TailGear_Boom_Mount_Sheet

AERO SENIOR TEAM

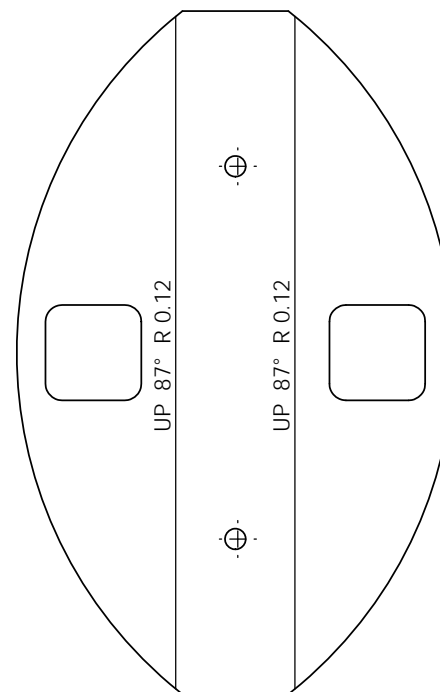
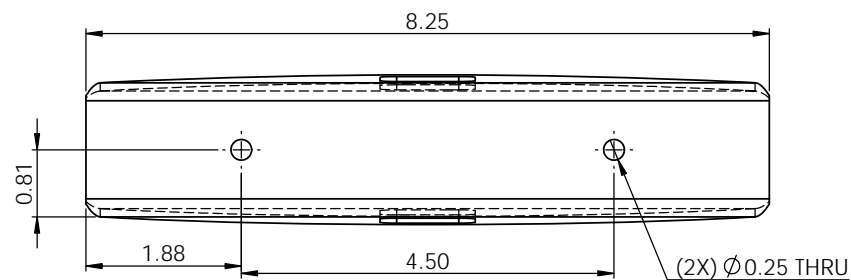
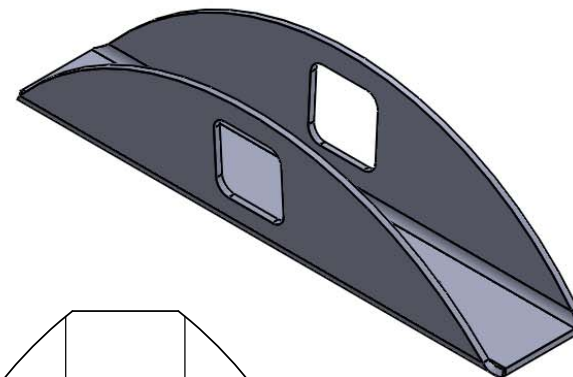
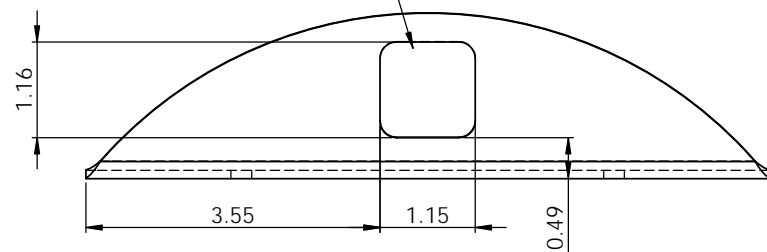
These Squares need to be aligned

Need both thicknesses: 0.10 and 0.0625 (1/16")
